CALIFORNIA ENERGY COMMISSION

**SUBJECT: Errata to the Russell City Energy Center Project (01-AFC-7C)
Staff Analysis of Proposed Modifications to Amend Air Quality,
Visual and Hazardous Materials Conditions of Certification**

Addendum to the Petition for Modification No. 4 Request to Amend Condition of Certification HAZ-5

VISUAL RESOURCES - FIGURE 4

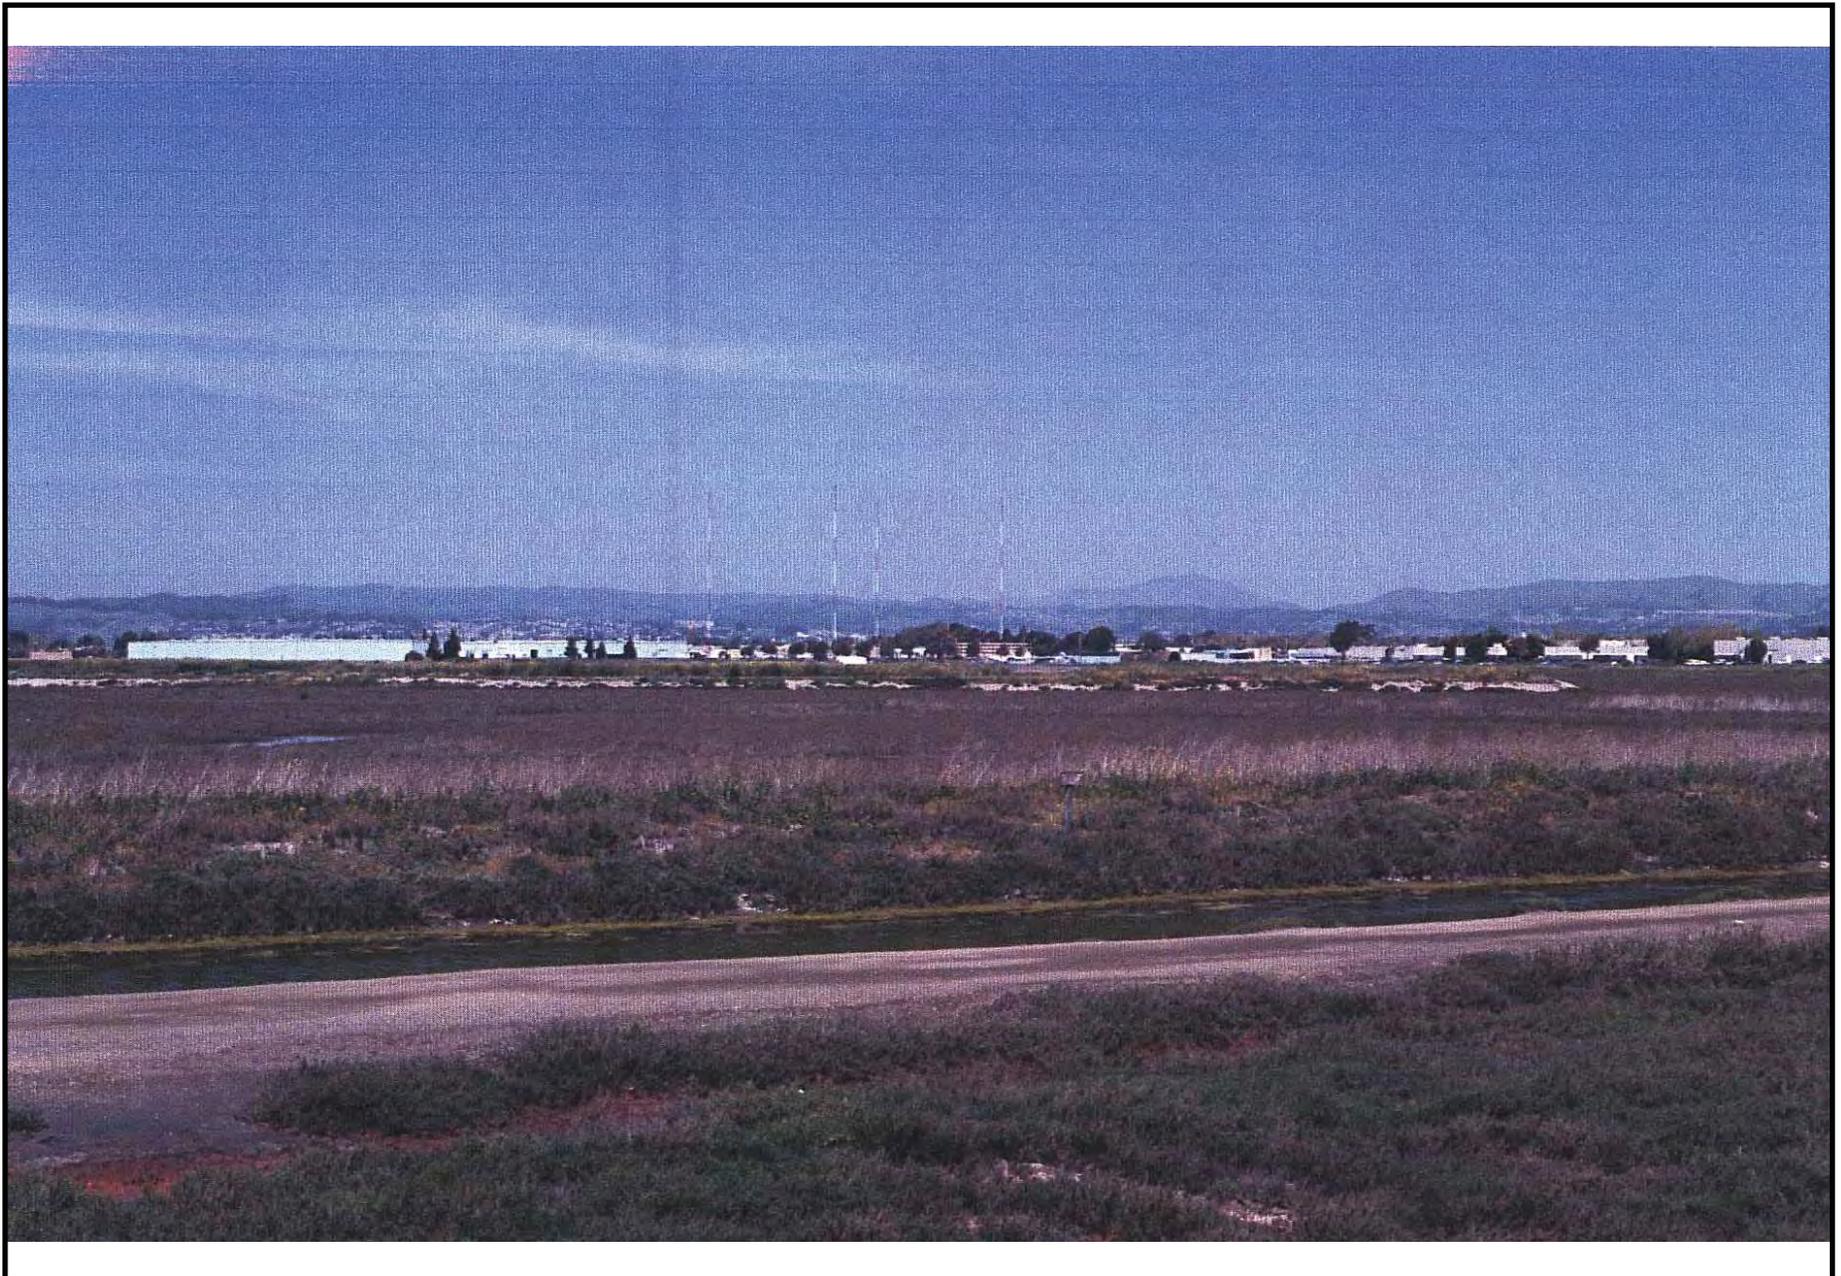
- modify Condition of Certification **VIS-2** to allow onsite landscaping to be planted after the start of commercial operation;
- delete Condition of Certification **VIS-9**; and,
- modify Condition of Certification **VIS-10** to allow in addition to the planting of trees, other plantings (e.g., bushes, shrubs, grasses), the installation of non-plant related

landscaping visual improvement items (e.g., masonry work, soil berms, slat inserts in fences), and the use of surface treatments (e.g., painting) on buildings and structures on neighboring properties to be completed 18 months after the start of commercial operation; and, to allow the use of planter containers.
